Access Compliance Report

Public Rights-of-Way

Intersection ID: N/A	Main Street: IDLEWILD_RD	Cross Street: E_INDEPENDENCE_RA	Location: SE
ADA ID: 1C6761C32221	Ramp Type: Perp	Initial Pass/Fail: Fail	Overall Compliance: No
		Severity Score: 12.5

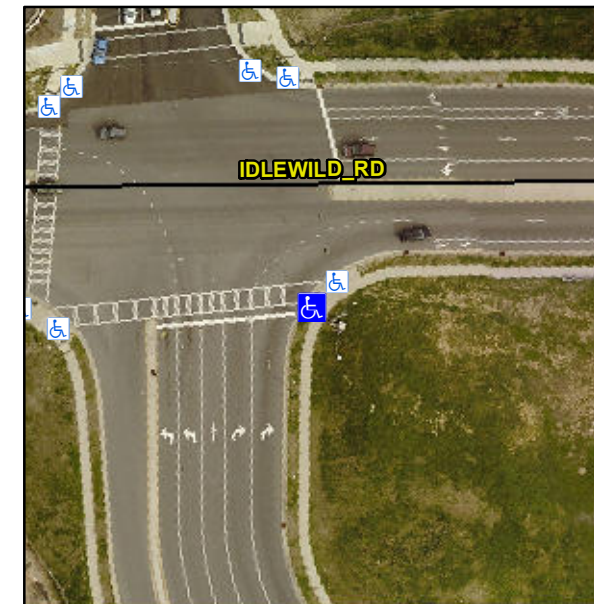
Not Found, R304.5.3

Compliance	Description	Data	Compliance	Description	Data
N/A	Ramp Length (in)	66.0	Yes	Ramp Slope (%)	7.6
Yes	Ramp Width (in)	59.0	No	Ramp XSlope (%)	6.9
N/A	Flare Type LT	N/A	N/A	Flare Type RT	N/A
N/A	Flare Slope LT (%)	N/A	N/A	Flare Slope RT (%)	N/A
N/A	Flare Traversable LT?	N/A	N/A	Flare Traversable RT?	N/A
N/A	Landing Length (in)	N/A	N/A	DWS Provided?	N/A
N/A	Landing Width (in)	N/A	N/A	DWS Contrast?	N/A
N/A	Landing Slope (%)	N/A	N/A	DWS Length (in)	N/A
N/A	Landing X Slope (%)	N/A	N/A	DWS Full Width?	N/A
N/A	Landing Curb? (Y/N)	N/A	N/A	DWS Offset (in)	N/A
N/A	Shared Landing?	N/A			
N/A	Gutter Ponding?	N/A	N/A	Gutter Slope (%)	N/A
N/A	Gutter Lip Ht (in)	N/A	N/A	Gutter X Slope (%)	N/A
N/A	Painted X Walk1?	Yes	N/A	Painted X Walk2?	N/A
	X Walk 1 Direction	To W		X Walk 2 Direction	N/A
N/A	X Walk 1 Width (in)	110.0	N/A	X Walk 2 Width (in)	N/A
	X Walk 1 Slope (%)	2.1		X Walk 2 Slope (%)	N/A
	X Walk 1 X Slope (%)	8.5		X Walk 2 X Slope (%)	N/A

Remove & Replace Entire Ramp.
